**CITY OF CHEYENNE BOARD OF ADJUSTMENT
MARCH 18, 2021
STAFF REPORT**

FILE: UDC-21-00067: 2300 Westland Road - Halladay Subaru
REQUEST: A Variance request to UDC 6.9.4.e.1, Primary Materials.
LOCATION: 2300 Westland Road
APPLICANT: Will Byers, The Design Studio, INC
OWNER: Jim Casey, Halladay Auto Group
ZONING: CB (Community Business) District
CASE PLANNER: Connor White, Planner II

APN: 20.2368
 Date Issued: 2021.02.17
 Drawn By: WZB
 Checked By: RLB
 Sheet Title: EXTERIOR ELEVATIONS
 Sheet Number: **A-211**

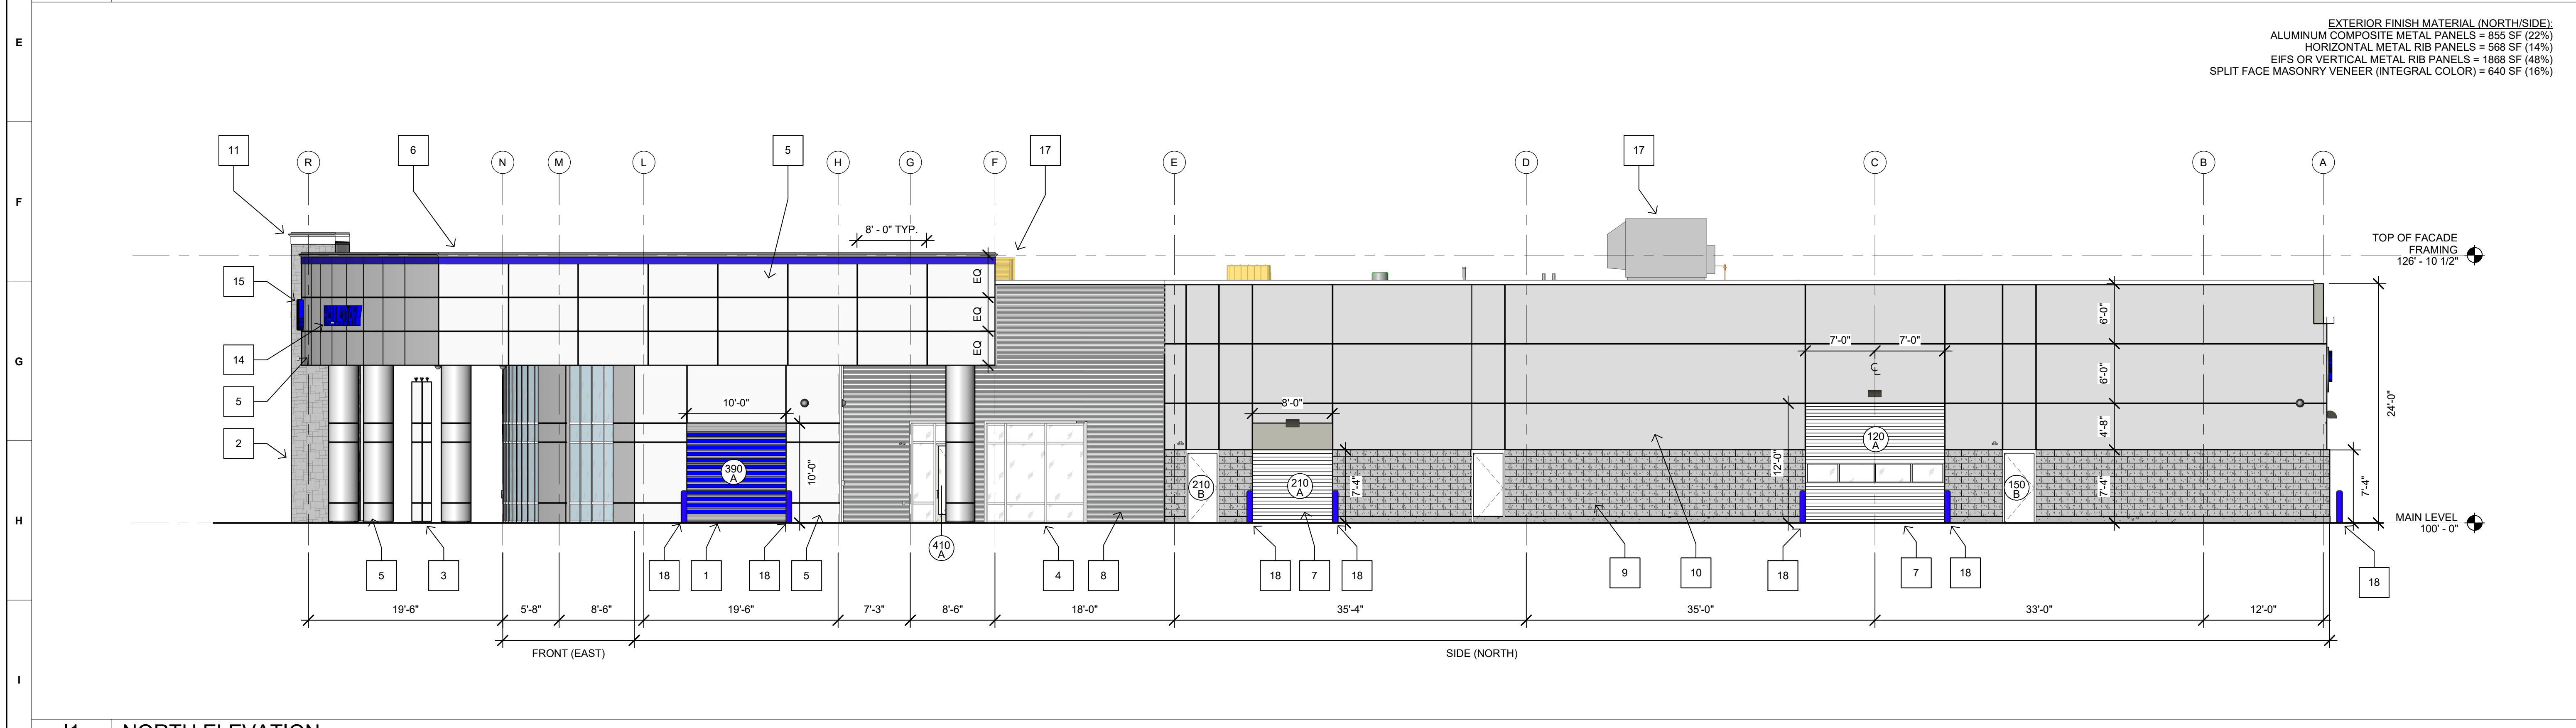
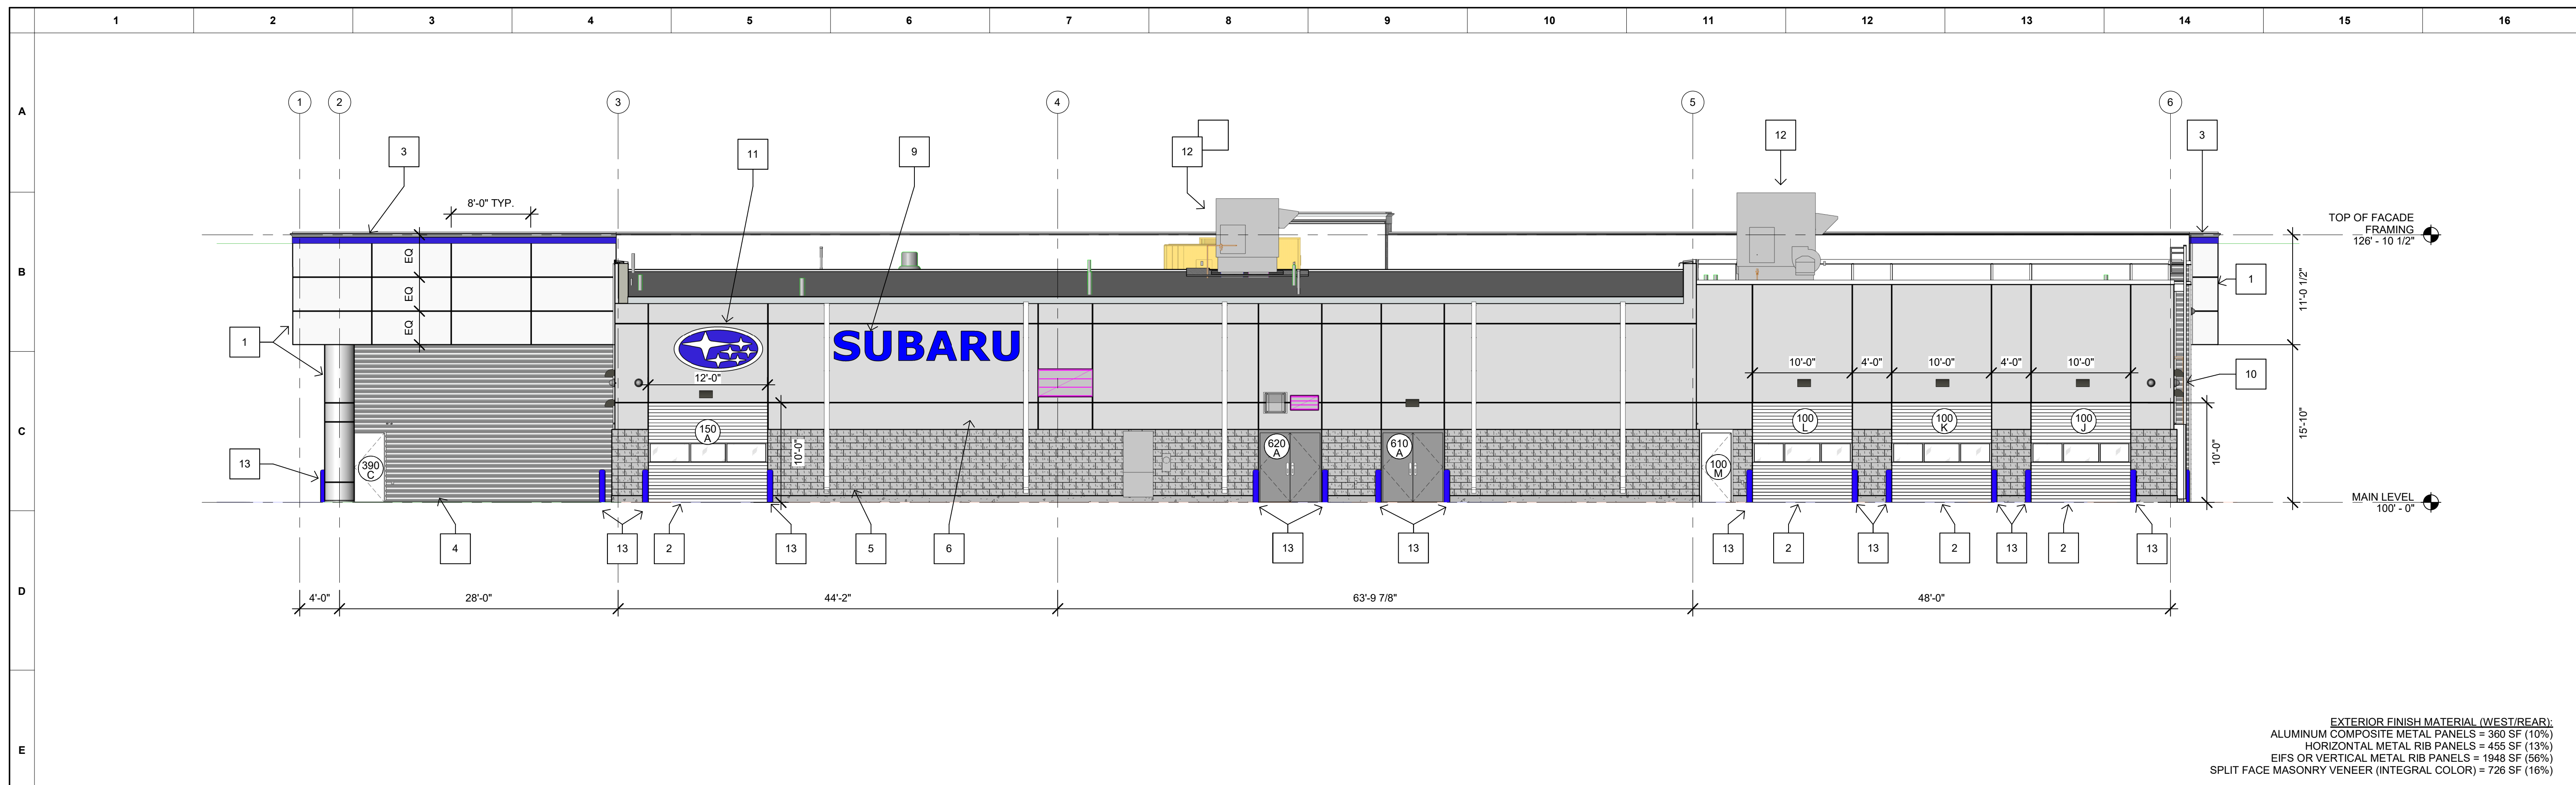
The applicant is requesting relief to UDC 6.9.4.e.1. This is a request to reduce the required percentage of primary materials of a new building from 30% to 20% on the east building facade, 16% on the north and west building facades, and 15% primary materials on the south building facade. The site presently operates as a car dealership (Outdoor Sales use). The applicant has a concurrent Site Plan application submitted as the site is being redeveloped with a new car dealership.

Staff recommends denial of the Variance request to UDC 6.9.4.e.1, Primary Materials to reduce the required primary materials from 30% to 20% on the east building facade, 16% on the north and west building facades, and 15% primary materials on the south building facade for a new car dealership at 2300 Westland Road due to the application not meeting the required review criteria.
